Addendum 2

37-15OCT13 - Boone County Walnut Office Columbia, MO

October 10, 2013 Addendum #2

1 PARKING LOT DRAINAGE
 ADD2 SCALE: 1/8"=1'-0"

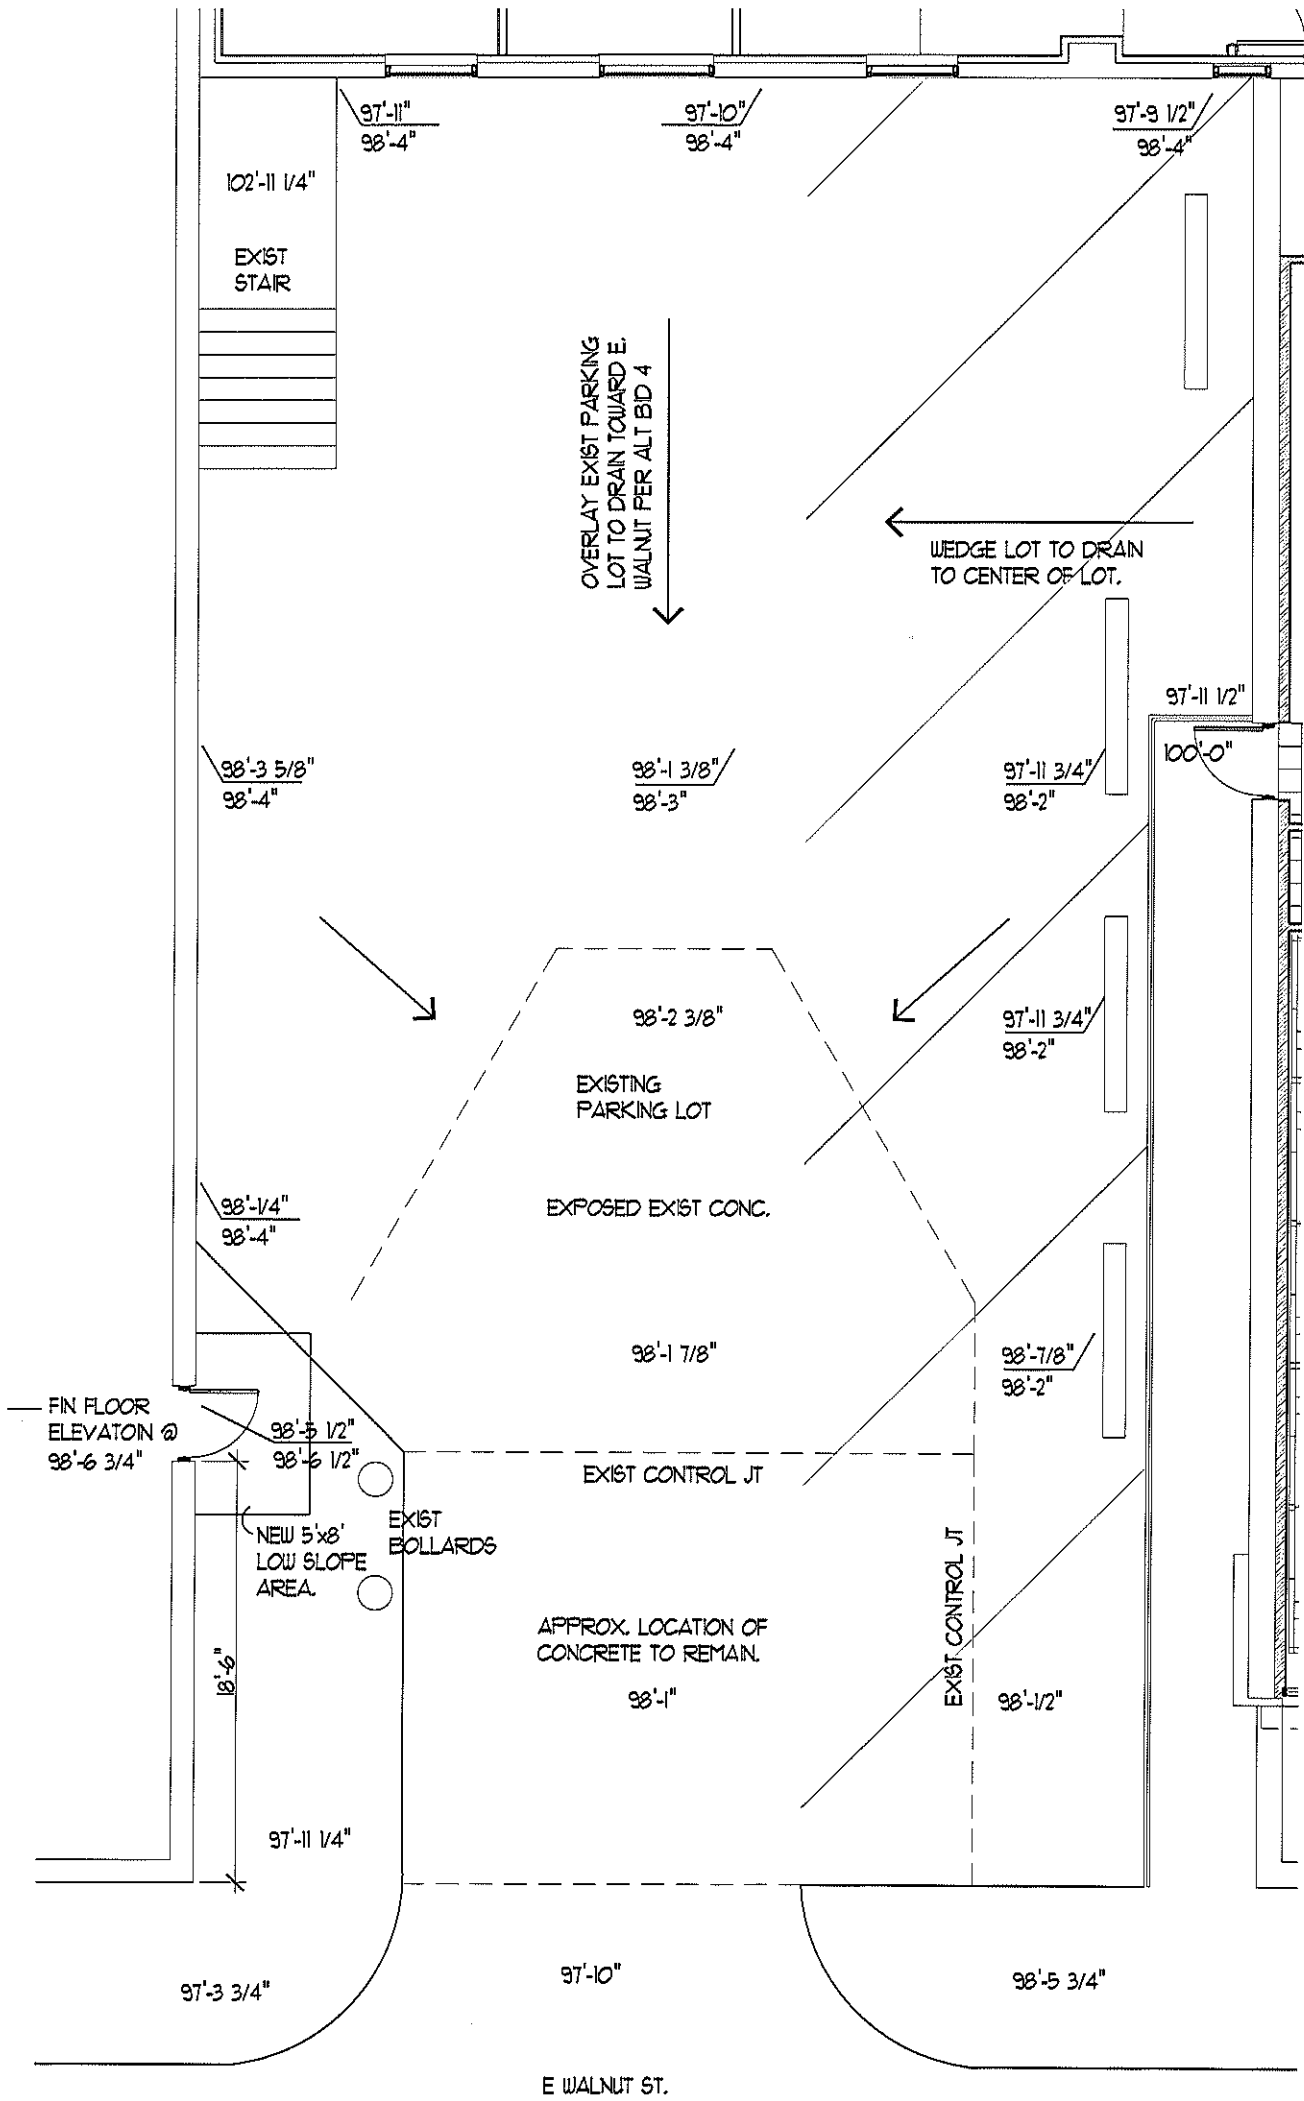
10. There shall be a 1 inch wrap insulation on the round duct.
11. Manko Window Systems is an acceptable storefront substitution
12. See attached revised sheet for the intent of sloping the existing parking lot.

E3.0

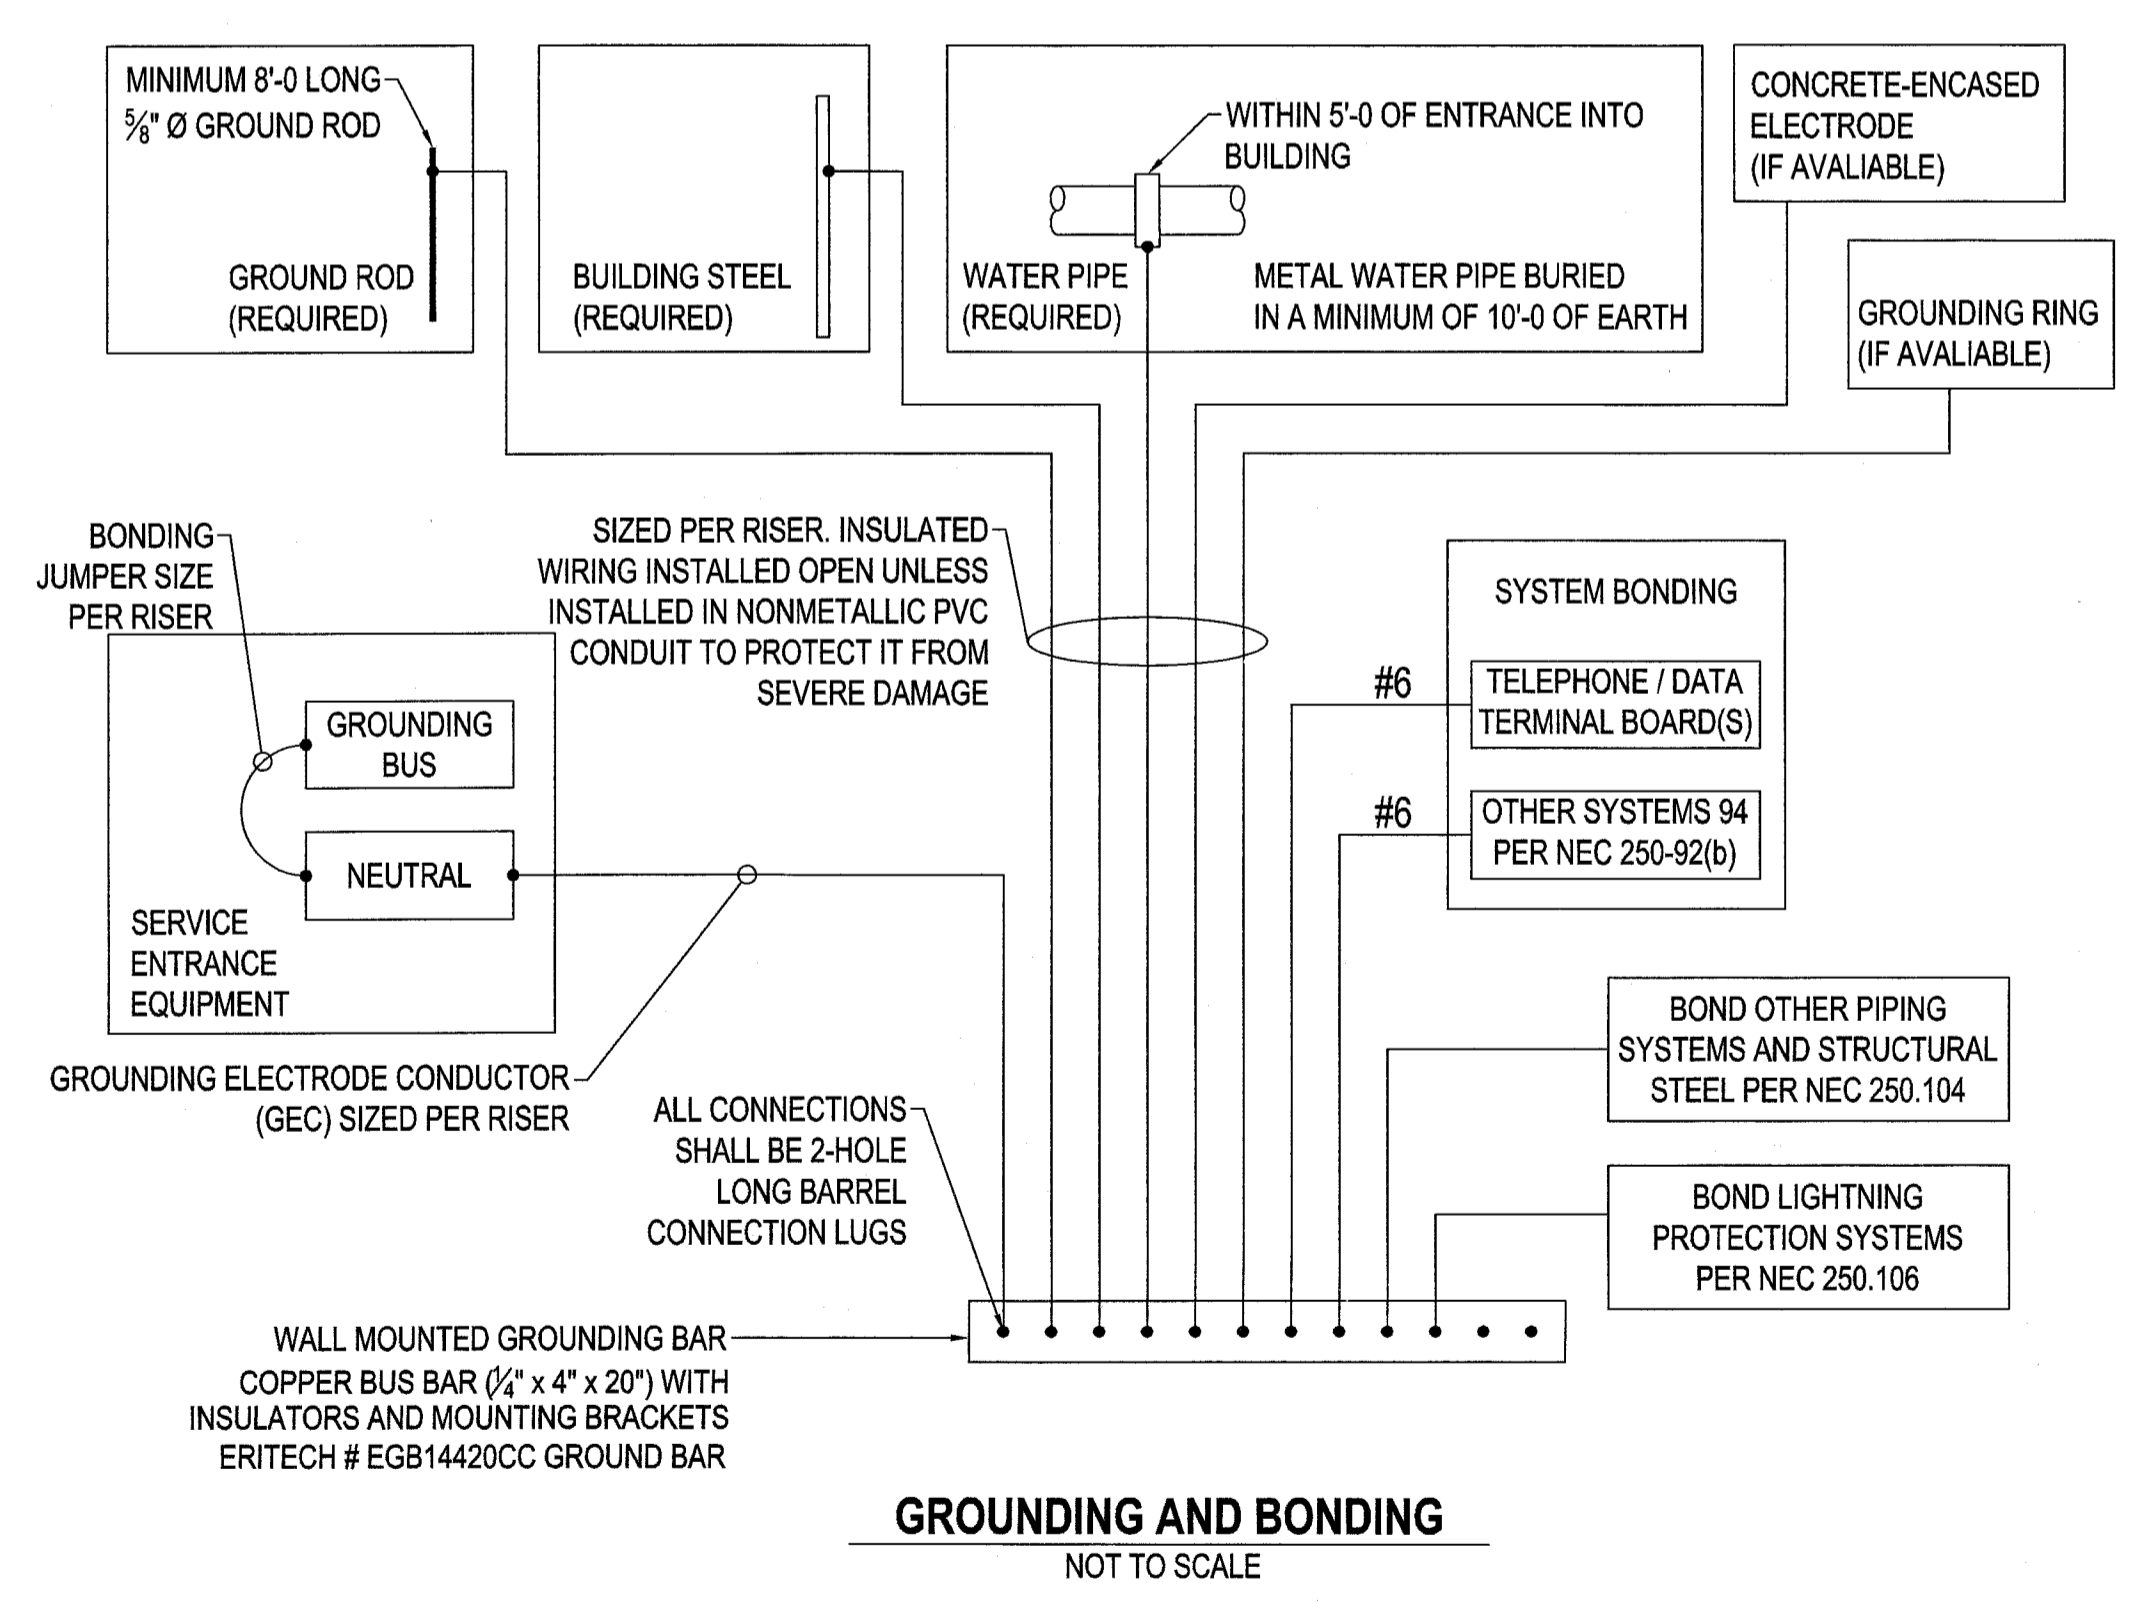
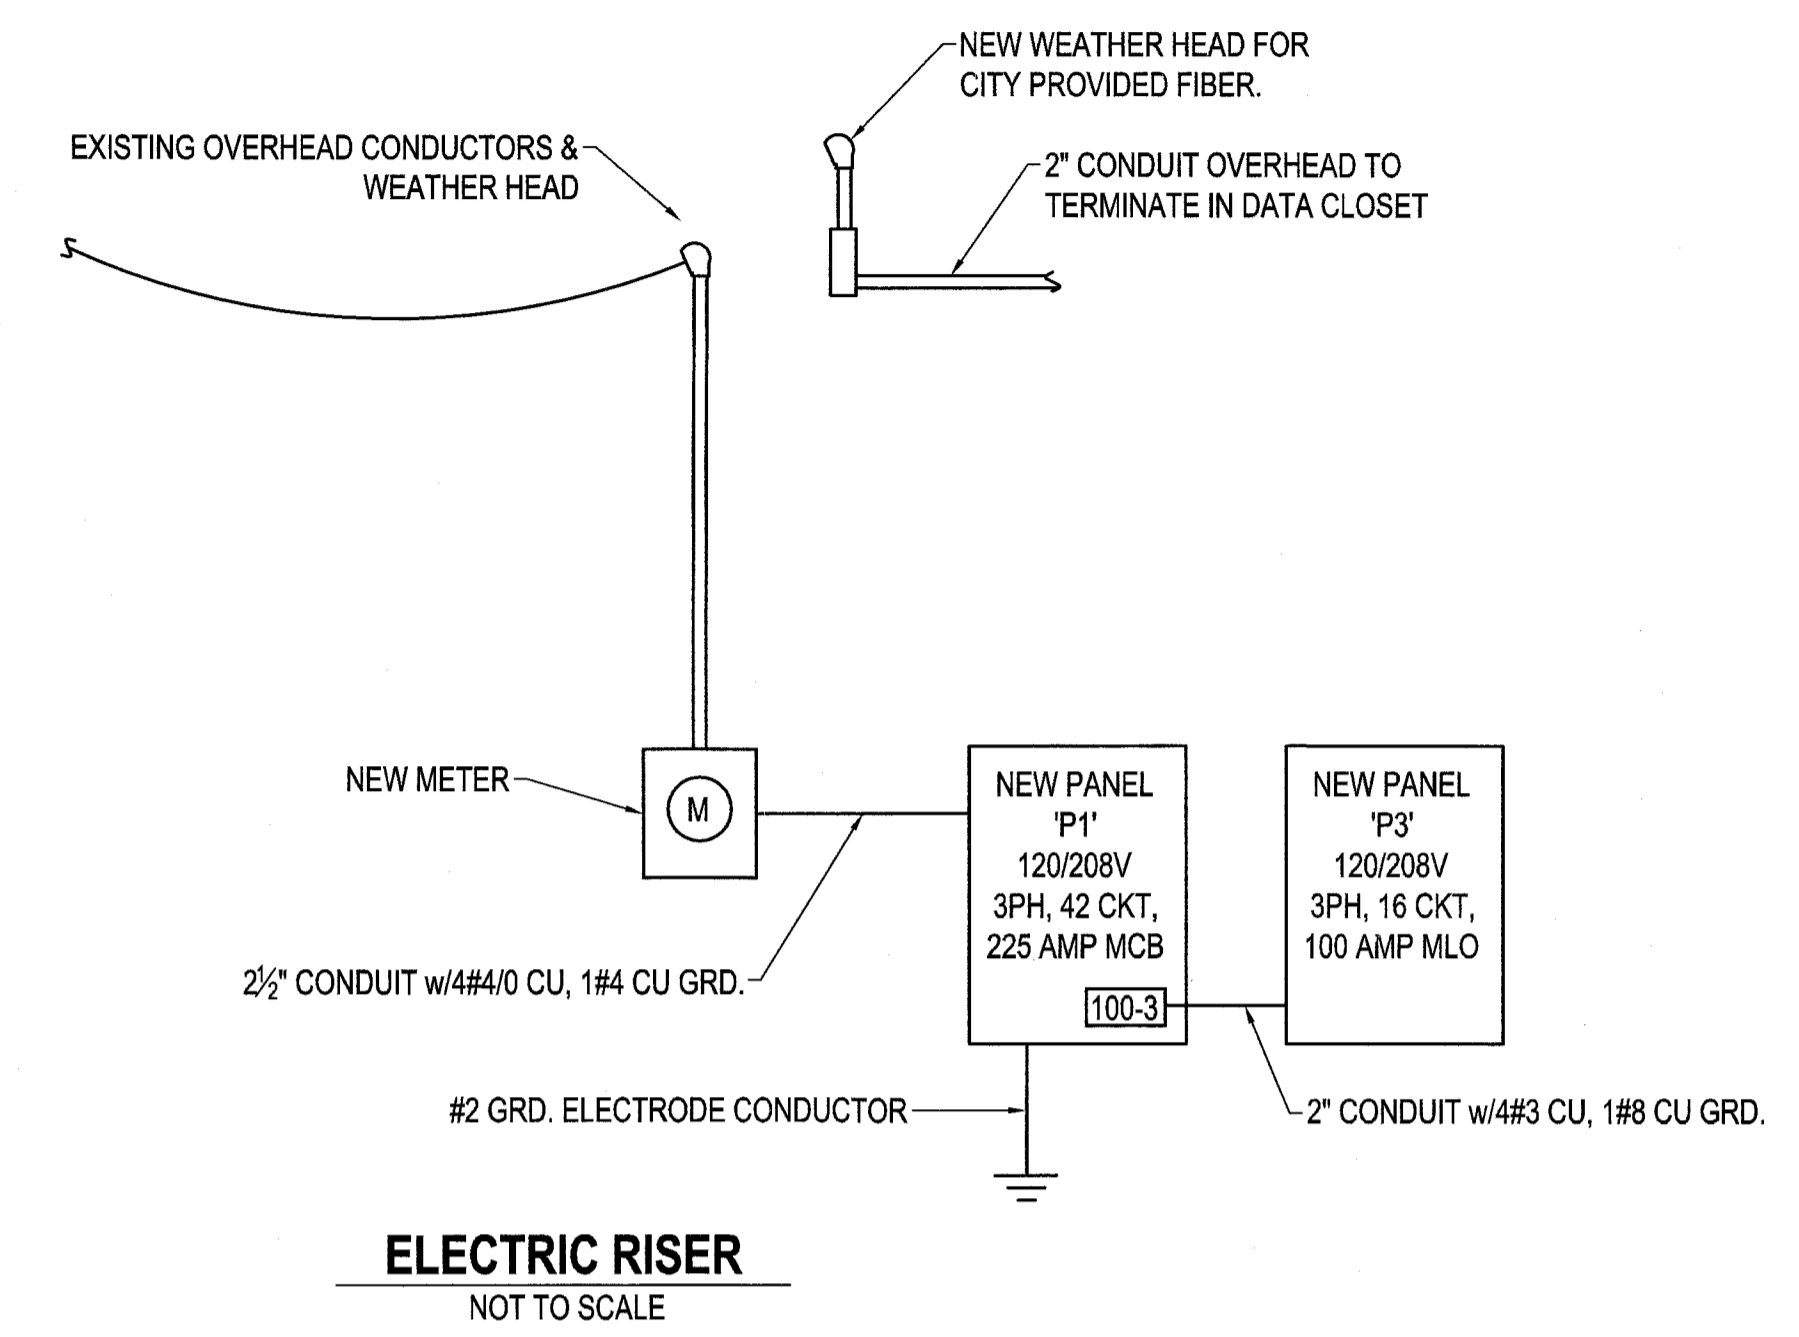
13. See attached revised sheet E3.0 for revised panel schedule.

REVISIONS:	DATE:
REVISED PANEL 'P1' SCHEDULE	10-8-2013
